ENVIROCARE OF UTAH, INC.
THE SAFE ALTERNATIVE

SUBJECT: Courtesy Copy of SERP Panel Findings

**SAFETY AND ENVIRONMENTAL REVIEW PANEL (SERP)
PANEL FINDINGS**

Docket Number: 11e.(2)99-012

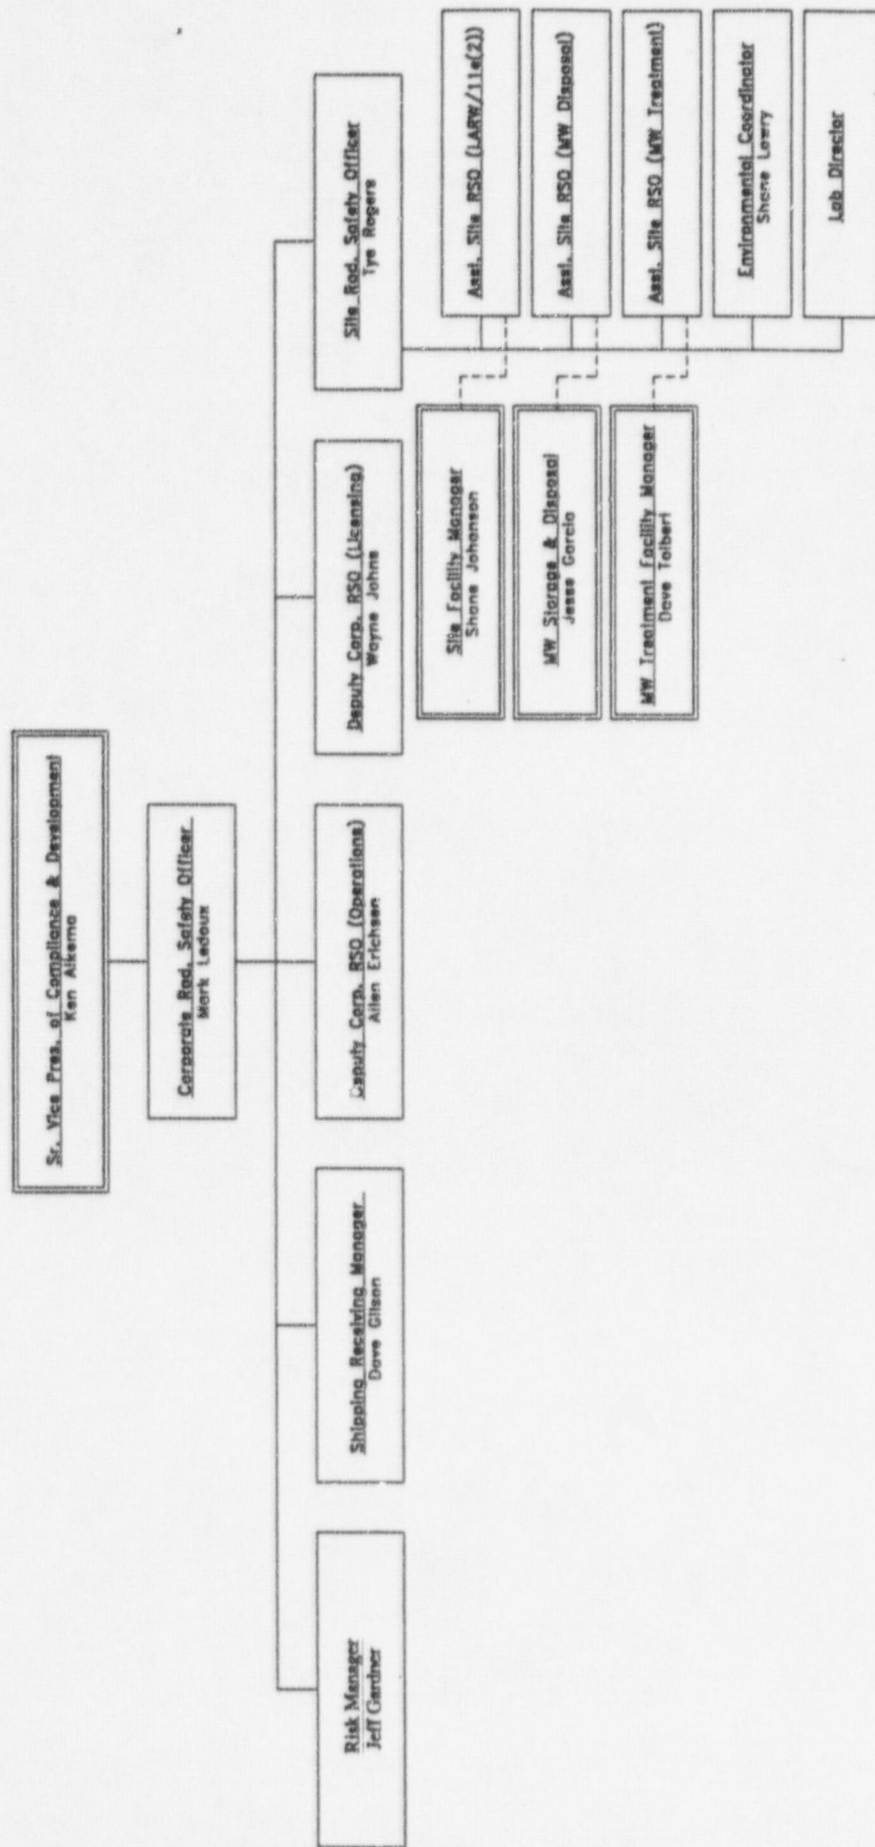
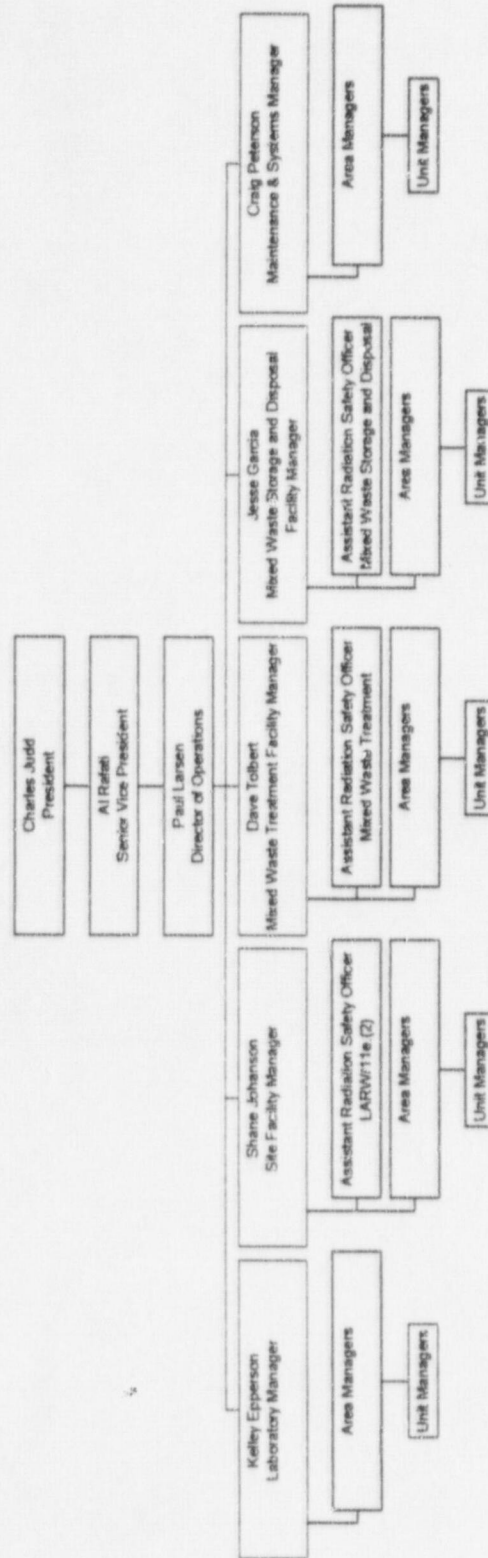
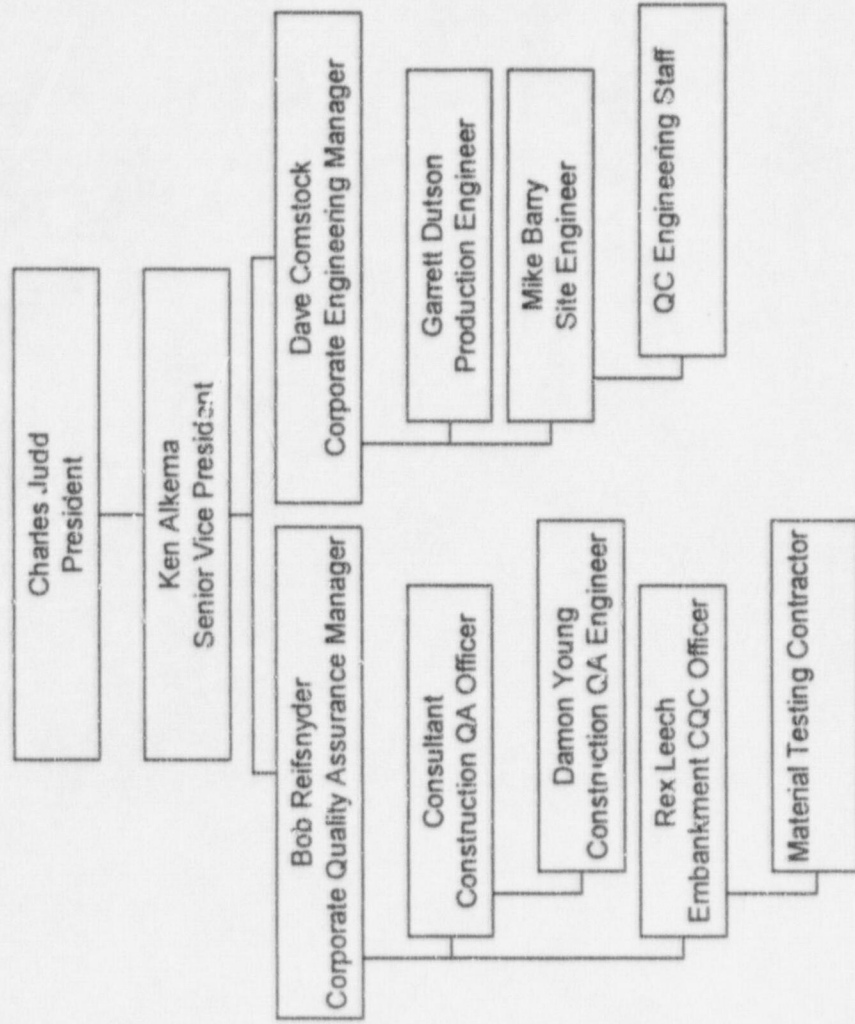
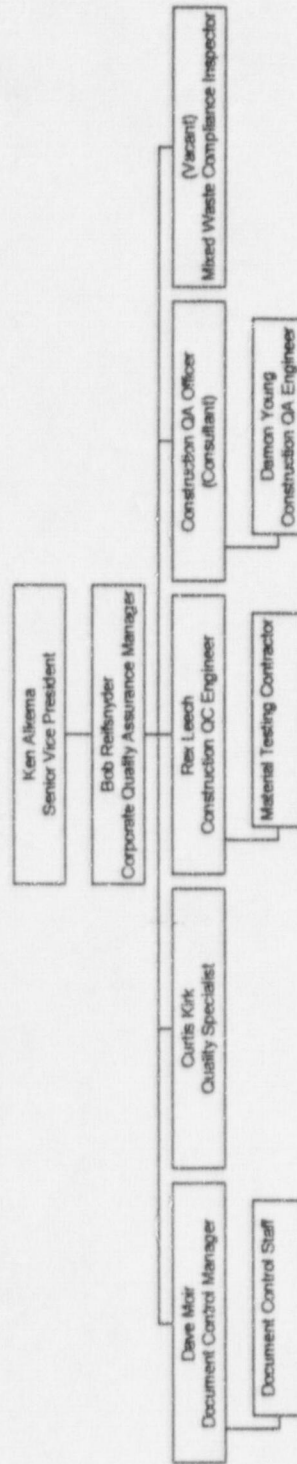
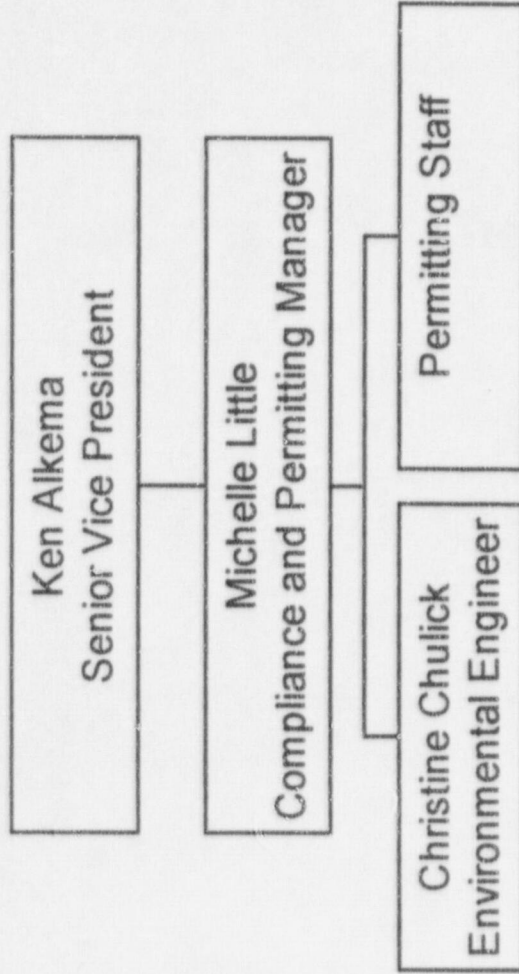
SERP Request Docket # 11e.(2) 99-013 requests that Section 18 and Section 17 of the License Application be revised to reflect the proposed organizational structure. The specific changes involve positions in the Operations and Radiation Safety Areas. The position of Deputy Corporate Radiation Safety Officer has been separated into two parts: one for Operations, and one for licensing. Also, the positions of Assistant Radiation Safety Officers have been instituted to assist the Area Facility Managers in the performance of Operation tasks. The Assistant Radiation Safety Officers will report to the Site RSO for radiation safety issues and the Facility Managers for operational issues. Additional changes included in the redline version are those that were included in SERP 11e.(2)99-006. SERP 99-006 was denied and a formal amendment request is to be submitted to the NRC. Changes included in SERP 99-006 were the change in authority over ground water and the CRSO.
